The Commission has issued the enclosed Amendment No. 8 to Facility Operating License No. NPF-16 for the St. Lucie Plant, Unit No. 2. The amendment consists of changes to the Technical Specifications in response to your application dated June 4, 1984.

The amendment revises the technical specifications for Cycle 2 operation of St. Lucie 2.

FLORIDA POWER & LIGHT COMPANY
ORLANDO UTILITIES COMMISSION OF
THE CITY OF ORLANDO, FLORIDA
AND
FLORIDA MUNICIPAL POWER AGENCY
DOCKET NO. 50-389
ST. LUCIE PLANT UNIT NO. 2
AMENDMENT TO FACILITY OPERATING LICENSE

By letter dated June 4, 1984, the Florida Power and Light Company (FP&L) submitted a request to reload and operate St. Lucie Plant Unit No. 2 for Cycle 2 (Ref. 1). In support of the request, the licensee submitted a reload safety analysis report (Ref. 2) and a statistical combination of uncertainties (SCU) methodology report (Ref. 3) applicable to St. Lucie 2.

Figure 2.1-1

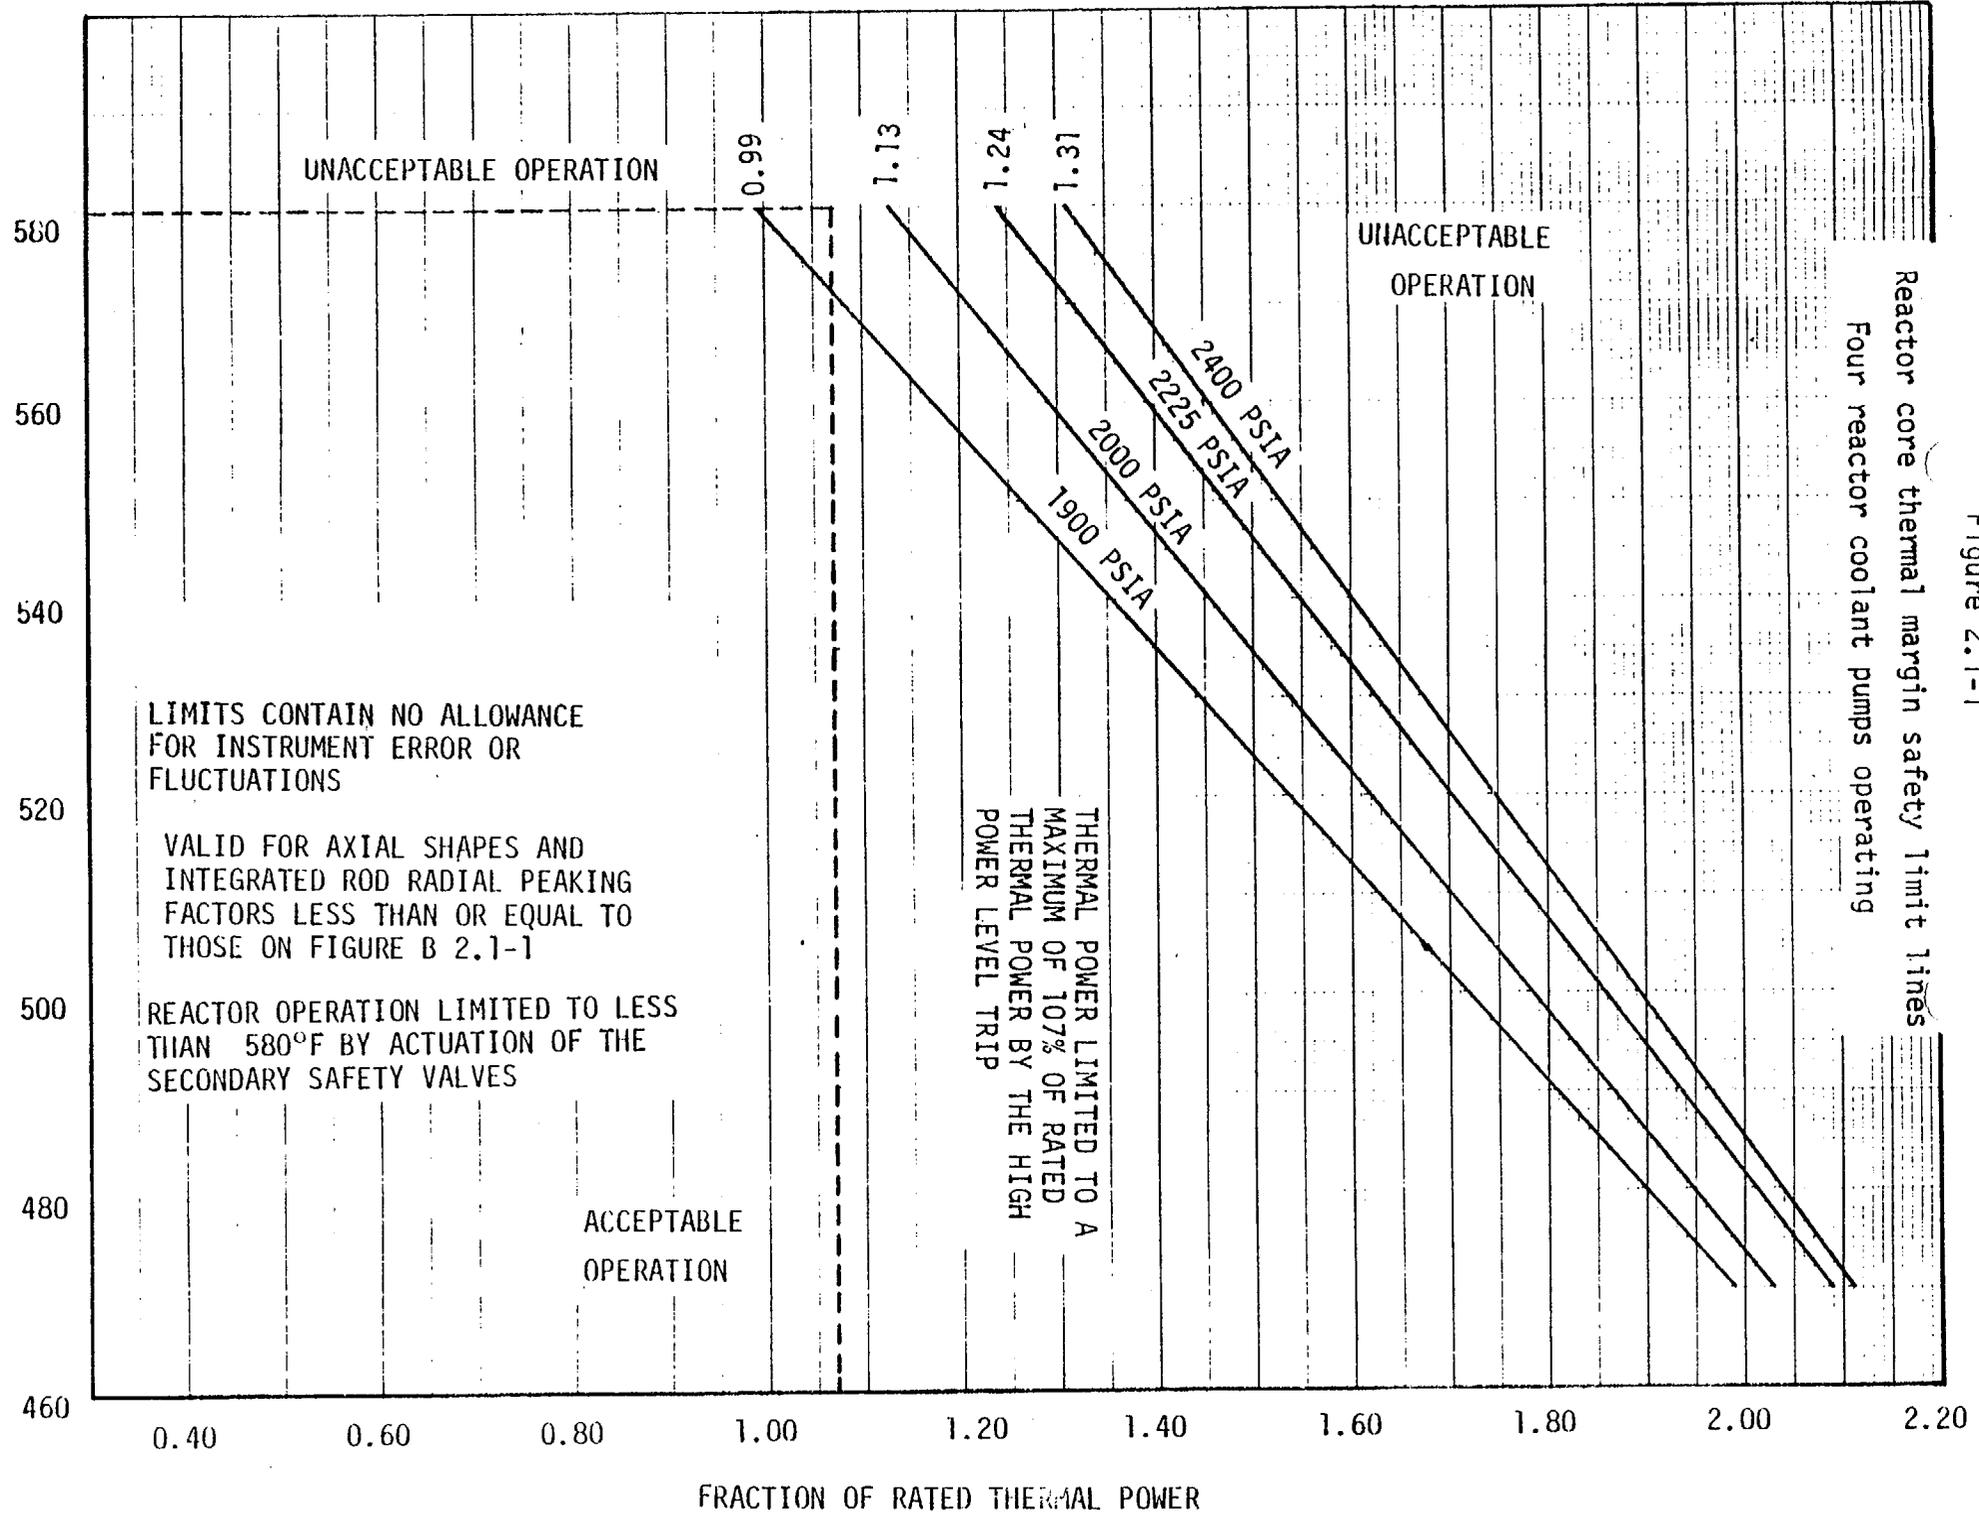
2. Figure 2.1-1 - The thermal limit lines have been revised. This change reflects the approved reanalysis at 2700 MWT, the approved Technical Specification radial peaking factors and the implementation of approved margin recovery programs and is, therefore, acceptable.

FIGURE 2.2-3

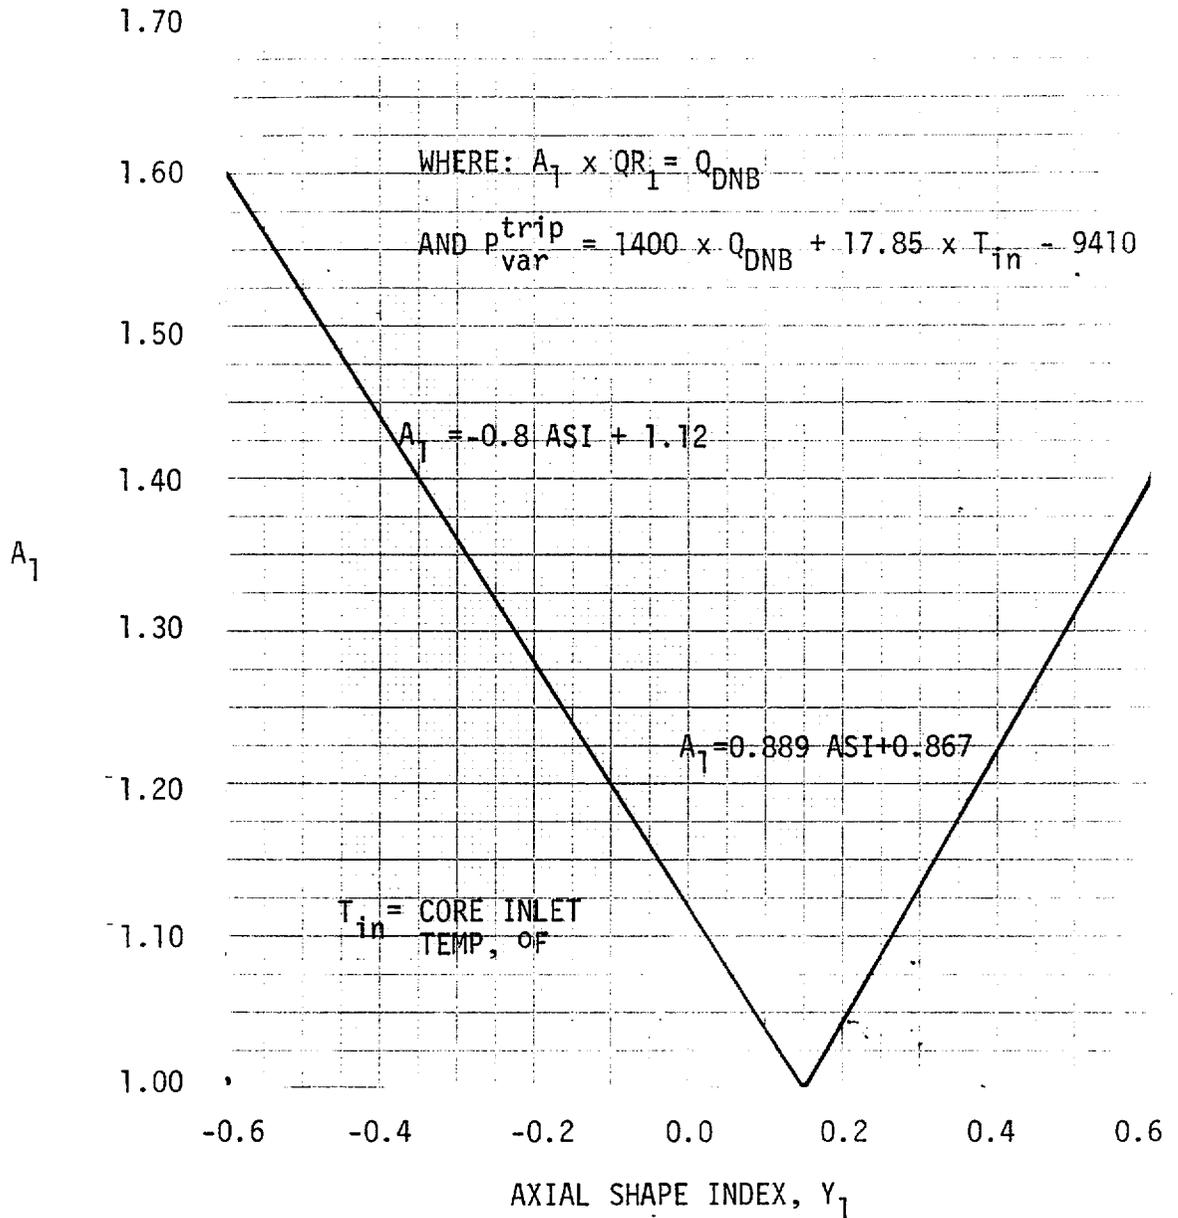
4. Figure 2.2-3 - The TM/LP LSSS has been revised. This change reflects the approved analysis at 2700 MWT, the approved Technical Specification radial peaking factors and the implementation of approved margin recovery programs and is, therefore, acceptable.

FIGURE 2.2-4

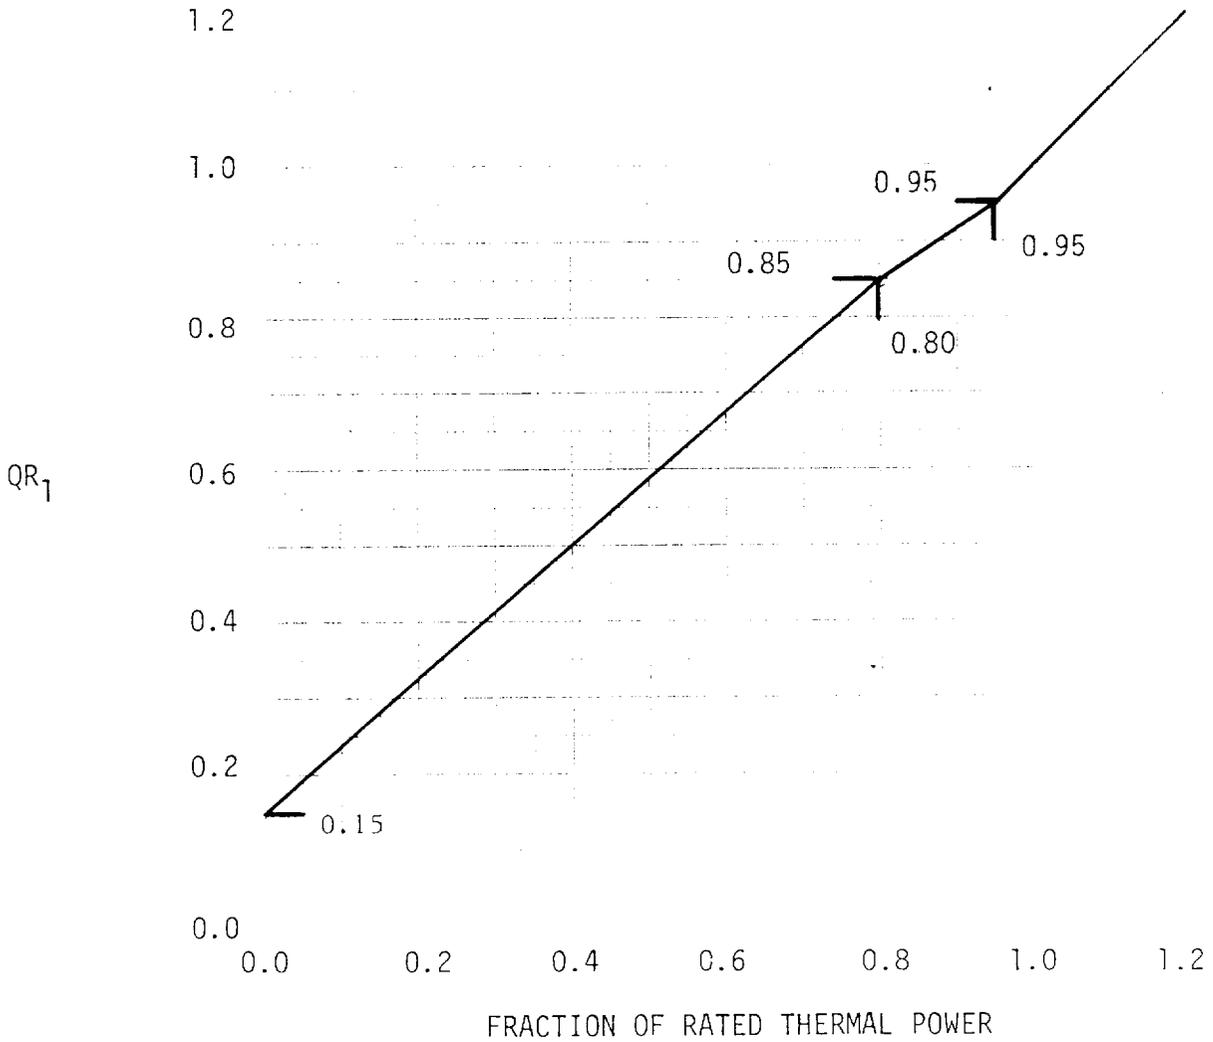
5. Figure 2.2-4 - This change is acceptable for the same reasons stated in 4. above.
6. Specifications B2.1.1, B2.2.1, and B3/4.2.5 - The value of minimum DNBR has been changed from 1.20 to 1.28. The new DNB limit has been derived using the Statistical Combination of Uncertainties (SCU) methodology (Ref. 3) which has been reviewed and approved in Section 7.0 of this SE and is therefore, acceptable. The initial request by FP&L to replace the actual minimum DNBR value by the phrase "the acceptable minimum DNBR limit" has been refused. The staff requires the bases to include both the value of 1.28 as well as reference to the use of SCU in its derivation.

Figure 3.1-1a
Allowable Time to Realign CEA vs. Initial F_R^T

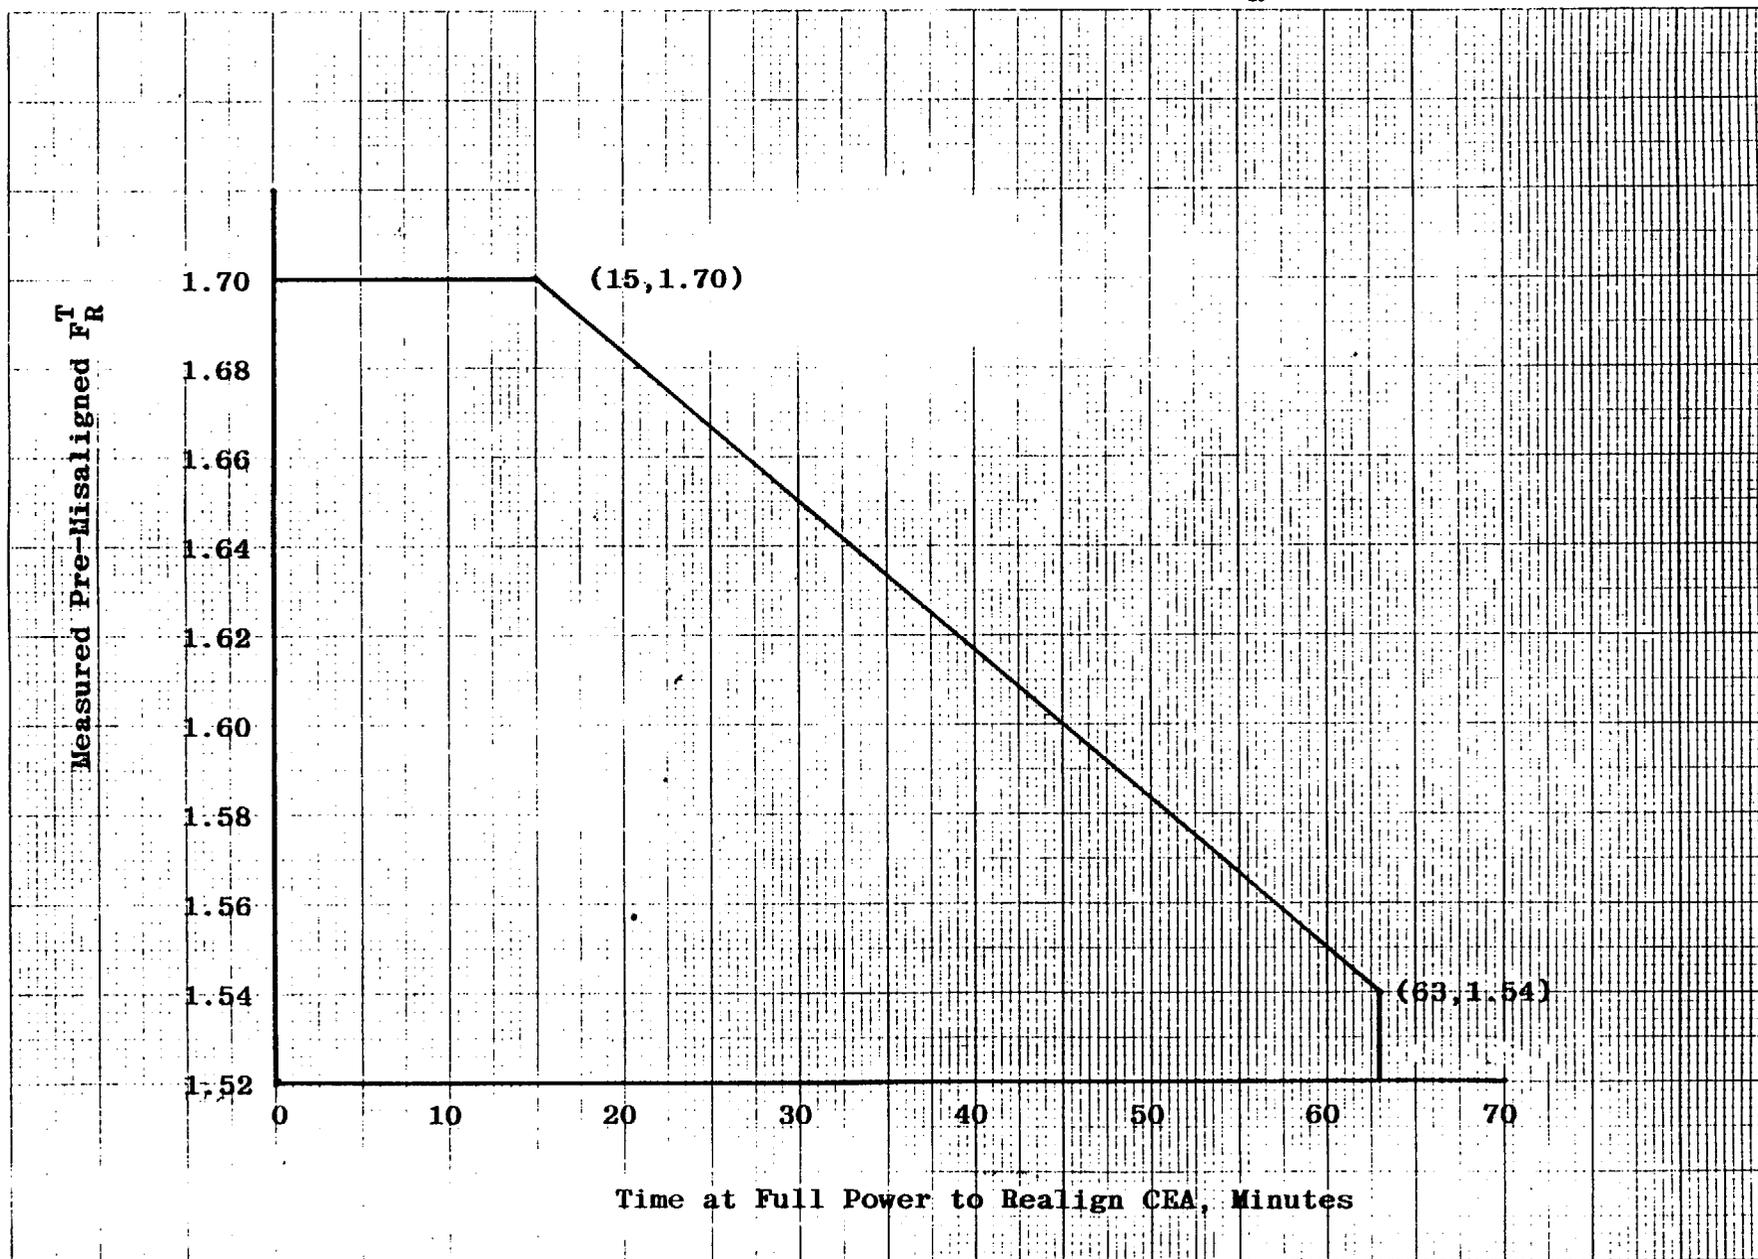
10. Specification 3.1.3.1 - The time constraints on misaligned CEA have been revised to reflect a newly inserted figure (Fig. 3.1-1a) showing allowable time to realign a CEA vs. measured initial F_T . This is acceptable for the reasons stated in Section 6.4.2 in this SE concerning the CEA drop event.

Figure 3.1-2

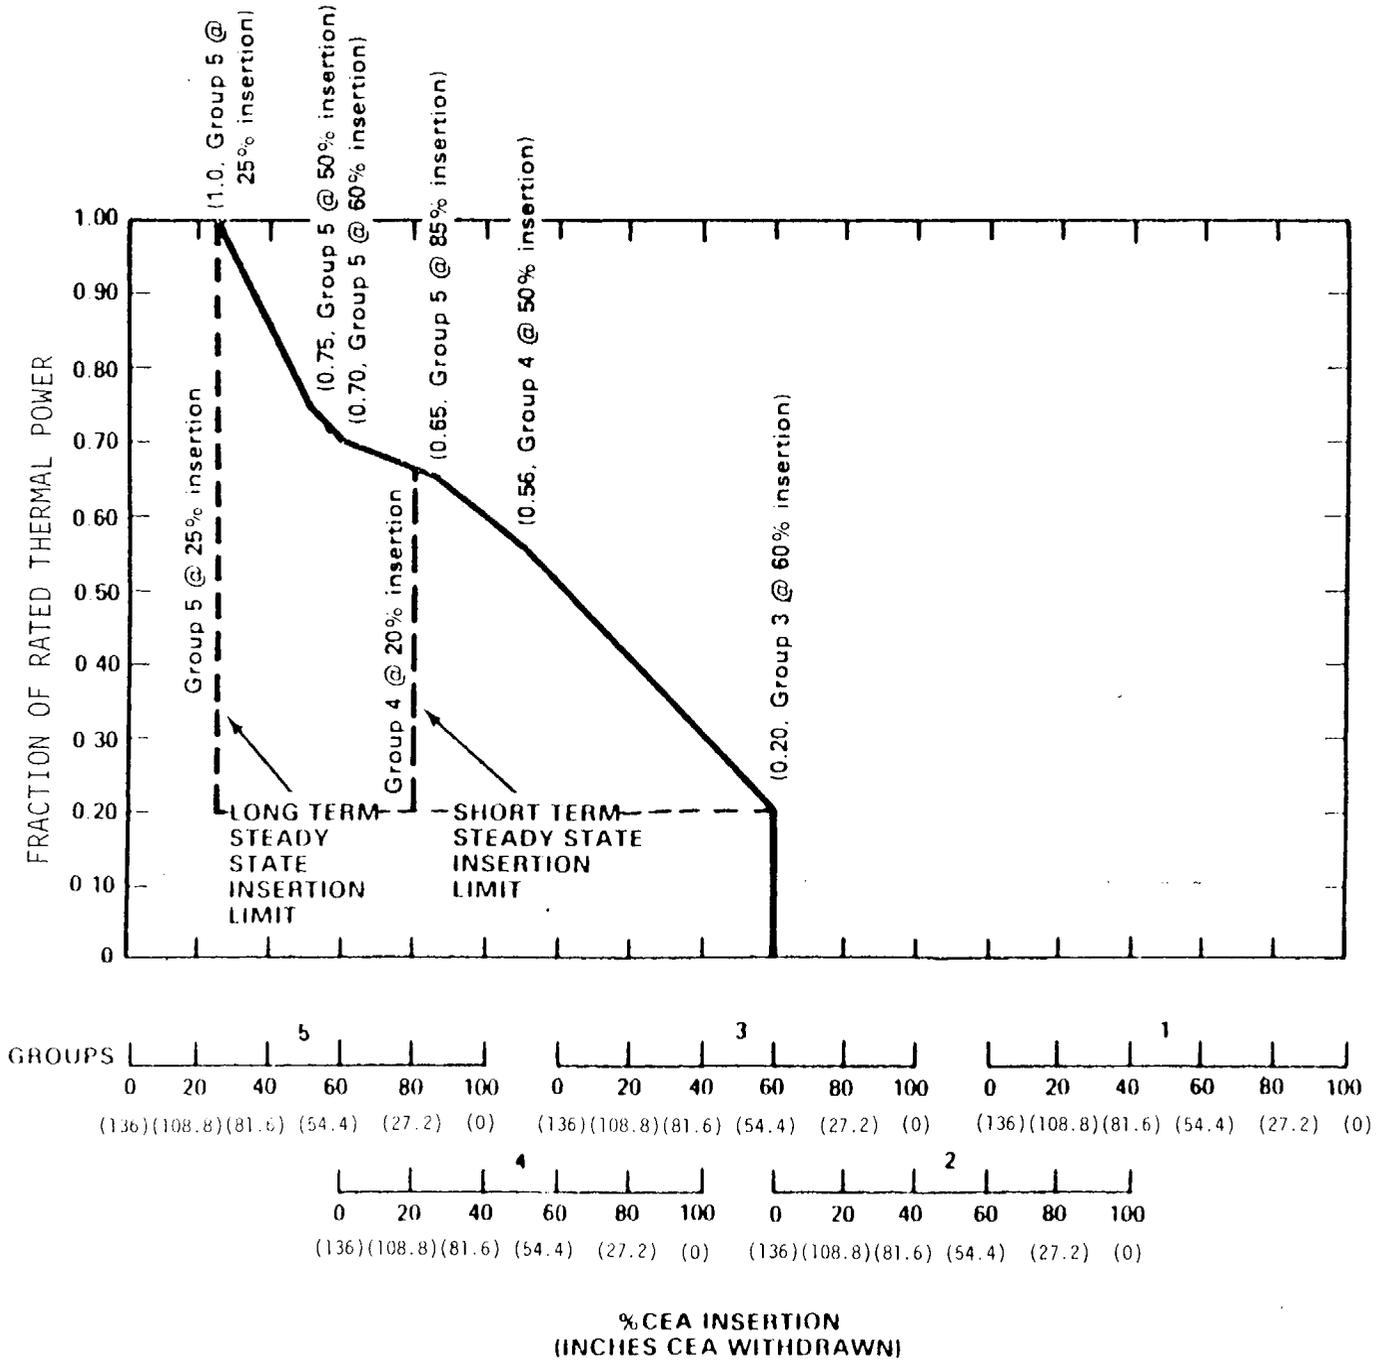
12. Figure 3.1-2 - The CEA power dependent insertion limits (PDIL) have been revised. This is acceptable since it is consistent with the new CEA grouping changes discussed in Section 3.3 of this SE.
